ENGINE SYSTEMS, INC.

Subject: 10CFR21 Reporting of Defects and Non-Compliance -
Engine Systems, Inc. Report No. 10CFR21-0124, Rev. 0

Excitation Transformers for Vickers Voltage Regulator System

Report No. 10CFR21-0124

Figure 2: EPT Outline Drawing

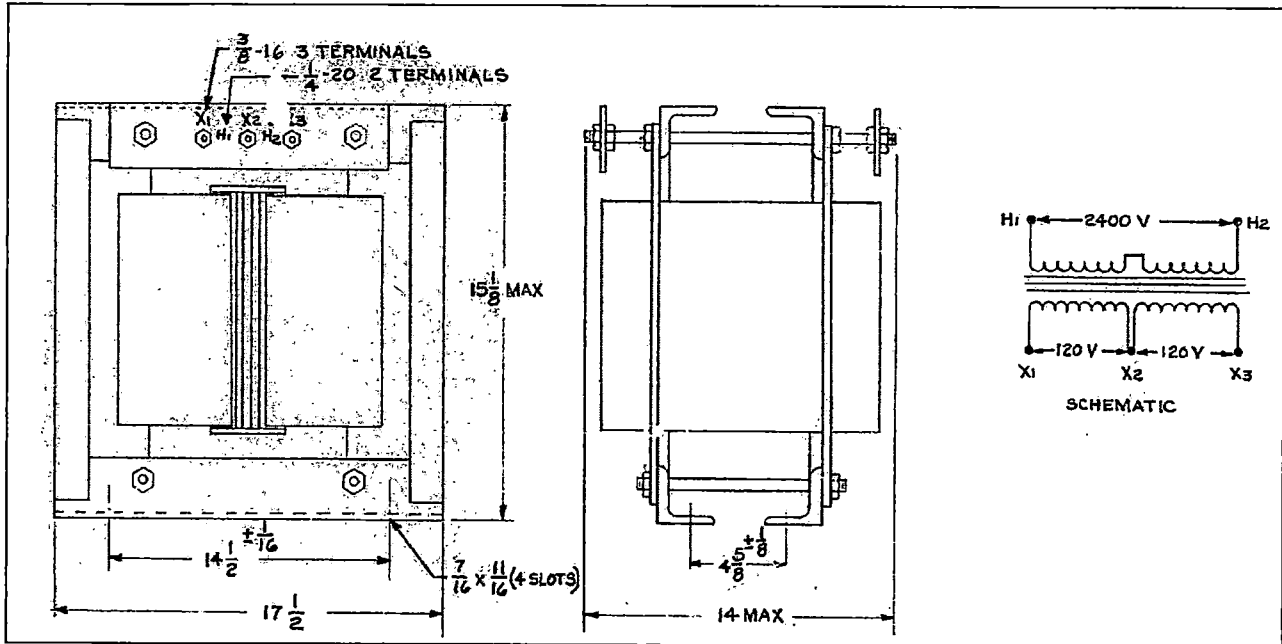
Three single-phase EPTs are wye connected on the primary and delta connected on the secondary. Per the system design, EPT primary H1 should have the same polarity of EPT secondary X1. Contrary to this requirement, EPT primary H1 has the same polarity as secondary X3.

Return to ESI for rework to have EPT primary terminal markings (H1 & H2) re-labeled.

Figure 3: PCT Outline Drawing

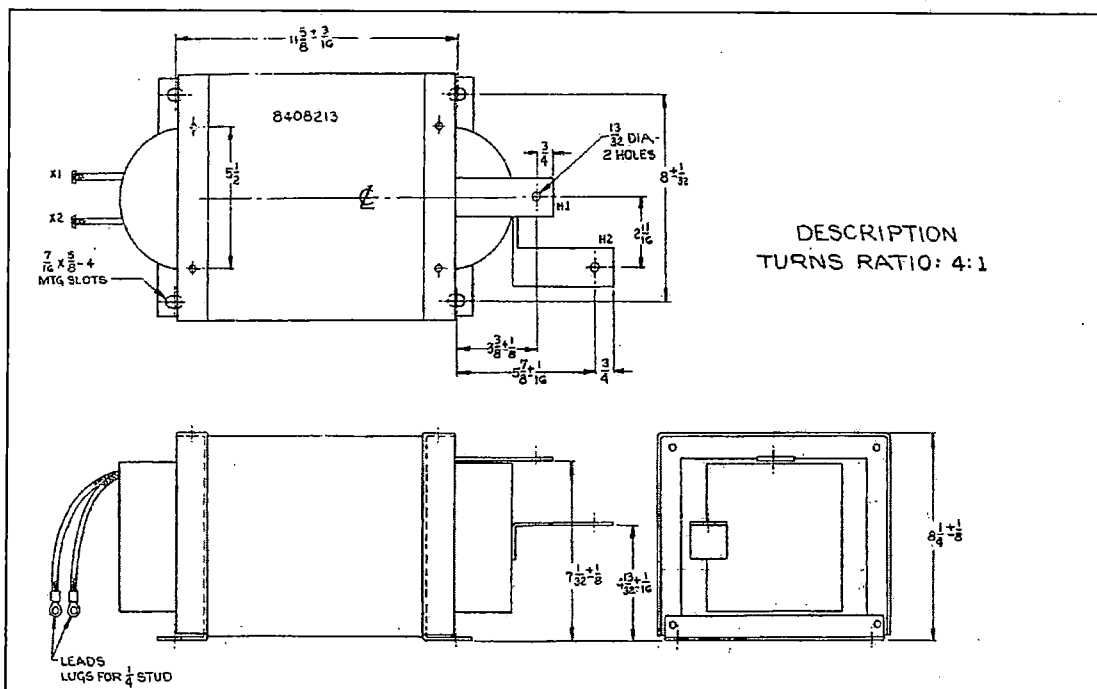
Three single-phase PCTs provide a secondary voltage proportional to the primary current. The PCT, in conjunction with the EPT, provide the power to support generator field excitation. Certain characteristics of the PCT secondary voltage are determined by the magnitude of an air gap in the core construction. It has been determined the PCT supplied by ESI has a gap of 0.030" whereas the original design PCT has a gap of 0.080".

Return to ESI for rework. The PCT requires additional insulating material to increase the core gap.

Figure 4: Reactor Outline Drawing

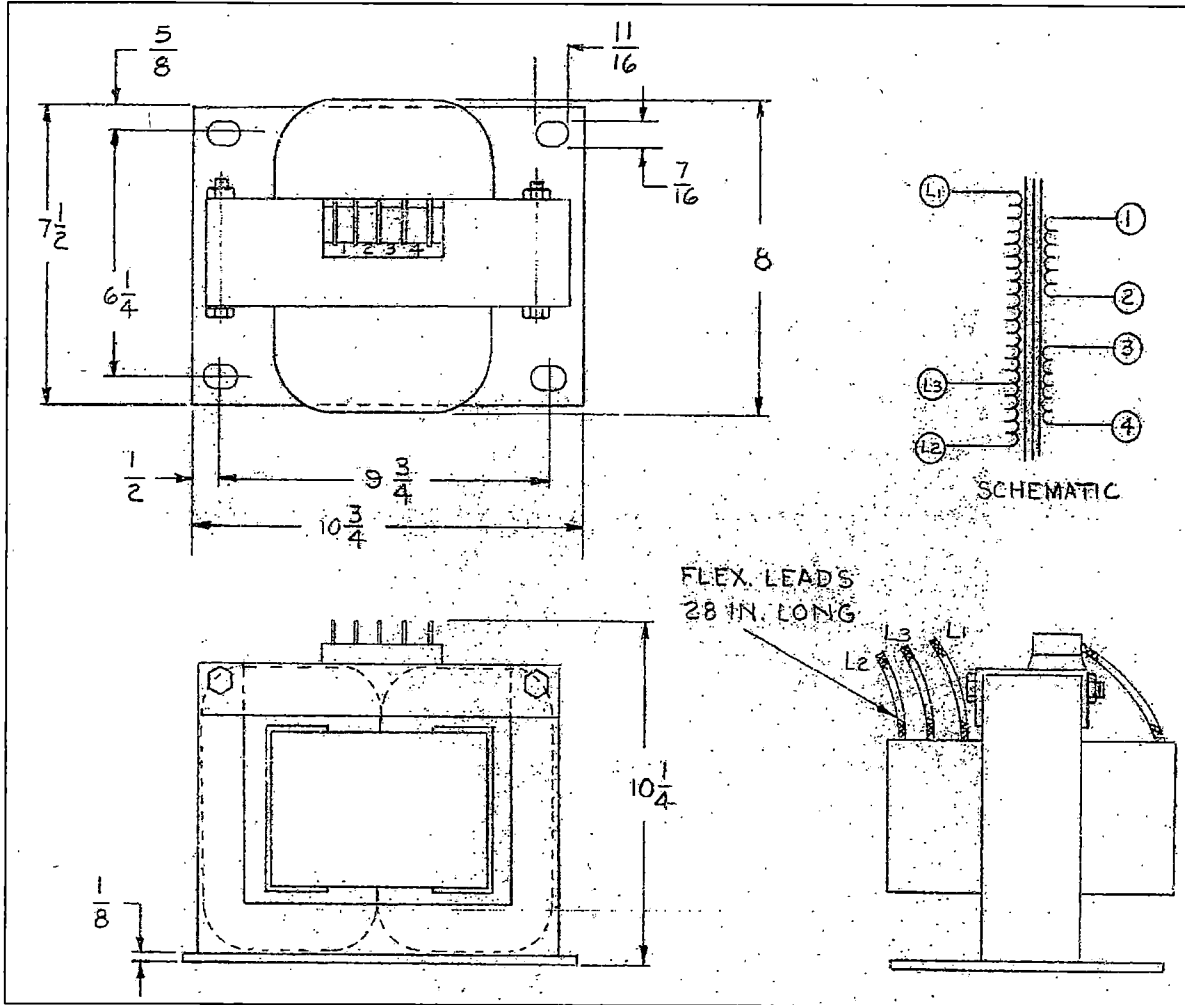
In conjunction with a rectifier diode, the saturable reactor acts as a magnetic amplifier. Six of these magnetic amplifier assemblies are used in the rectifier bridge of the voltage regulator system. The reactor receives a bias and control current from the voltage regulator which varies the level of saturation in the reactor core. As the level of saturation changes, the reactor impedance varies which increases or decreases generator field voltage. It has been determined the saturable reactor supplied by ESI has coil winding and core winding differences from the originally supplied reactor that may cause subtle, but undesired performance differences.

Return to ESI for replacement.
